Meeting Date: May 26, 2021
Item Number: 2

PLANNING COMMISSION AGENDA REPORT

SUBJECT: Review of a Tentative Tract Map (Tract 3157) to create 23 residential lots on a 4.98-acre site within the Low-Density Residential (R-1) zone. Project includes the extension of Stanford Drive, which will connect to an extension of Cuesta Drive. An Initial Study/Mitigated Negative Declaration is proposed (CEQA).

FILE NUMBER: SBDV-0169-2020,
EID-0170-2020

Figure 1: Subdivision Design Circulation Connections

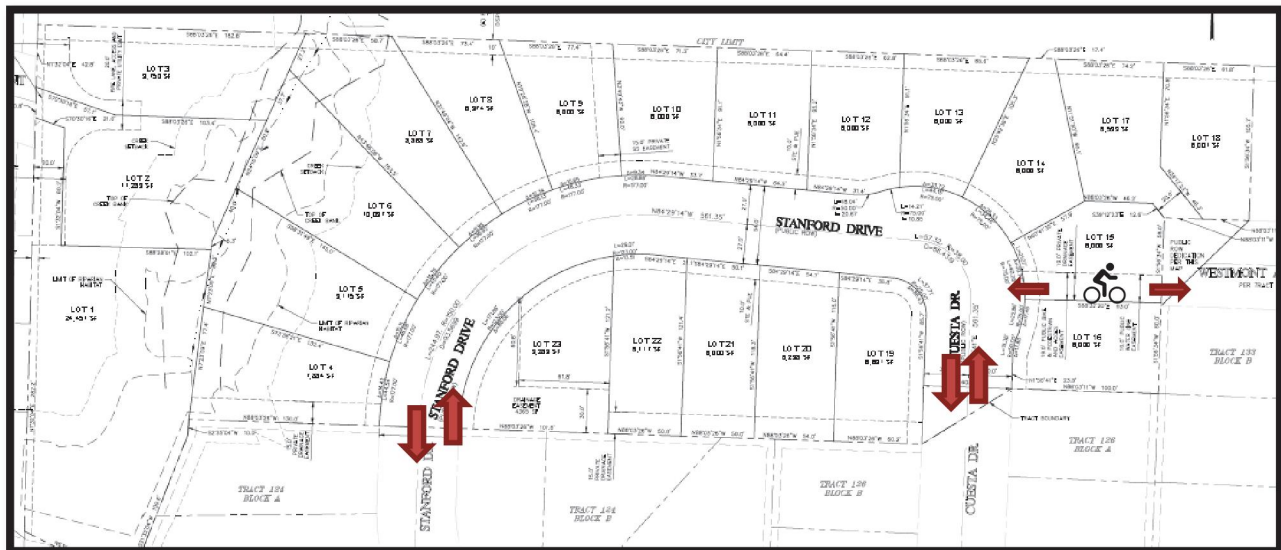
The design of the subdivision protects the existing neighborhood from intrusive traffic by only connecting the two existing streets to the south, avoiding any increase in cut-through traffic between other existing neighborhoods and Highway 1. The subdivision design also incorporates a potential bicycle and pedestrian connection to the east, as well as parkways, on-street parking, and sidewalks.

Figure 2: Cuesta Drive Street Design Connection to Existing

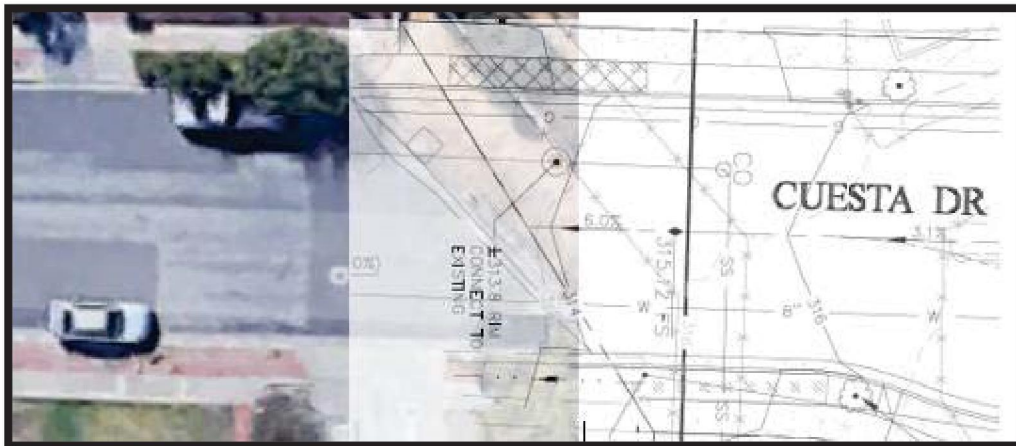
The design of the subdivision integrates with the existing neighborhood by continuing the street layout of Stanford and Cuesta Drive, including street width, sidewalks, and parkways (see Figure 2 as example).

Figure 3: Creek Corridor, trees number in black within setbacks are retained

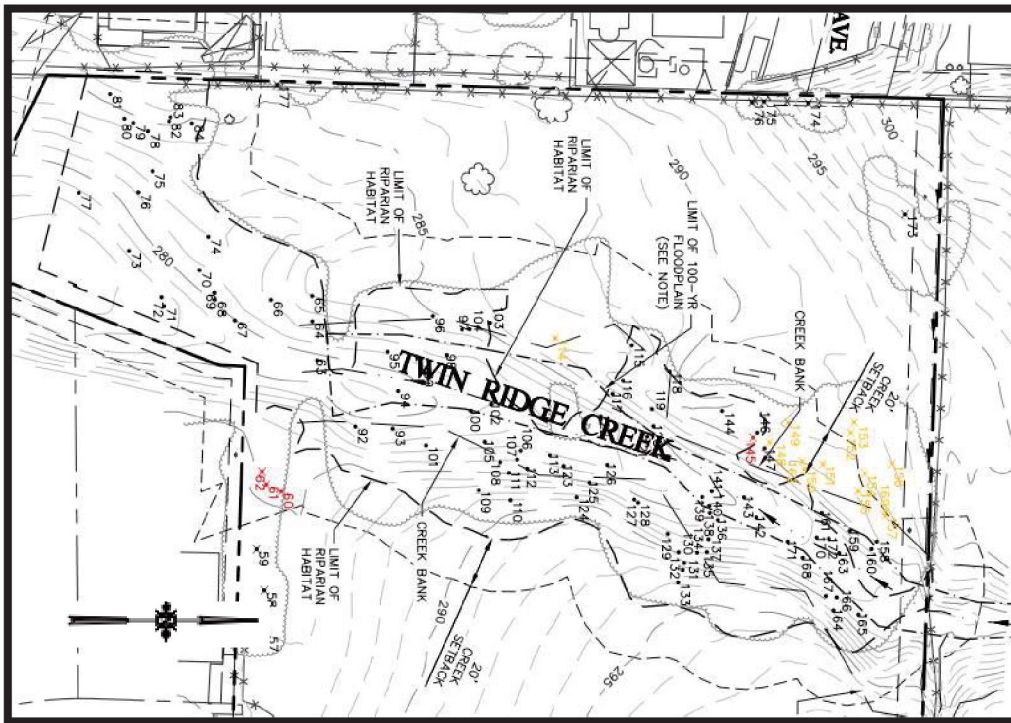
The TTM identifies the dimensions of the creek and existing riparian area. The lots proposed adjacent to the creek are a larger size so that creek protection measures, such as compliance with creek setback requirements, can be met and still allow development of the created parcel. The TTM also proposes no development or grading activities in the southwest corner of the site, where the creek and associated vegetation is most prominent and established. In all, over 60 coast live oaks, will be retained within the protected creek corridor area, as well as other native species.
